UNITED STATES PATENT AND TRADEMARK OFFICE

APPLICATION NO.	FILING DATE	FIRST NAMED INVENTOR	ATTORNEY DOCKET NO.	CONFIRMATION NO.
10/820,636	04/08/2004	Sridhar Ranganathan	17,872	8821

Office Action Summary

DETAILED ACTION

Fig. A: Examiner's markup of Gertzman's Fig. 2 to identify subtended angle.

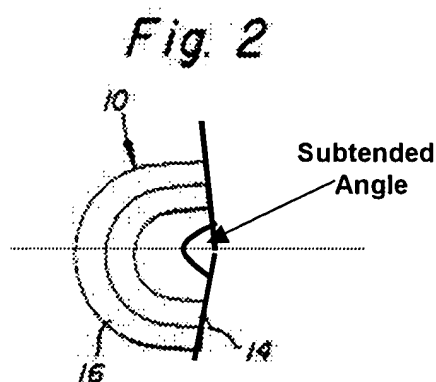
In regard to Claims 7, in Fig. A below, the structure 10 of Gertzman et al. is marked up based on examiner’s understanding of “subtended angle.” As can be seen in Fig. A, the absorbent structure 10, has a subtended angle of about 180 degree or less.

Furthermore, this property is considered to be inherent based on the same structure/same property as provided in the discussion of Claim 1.
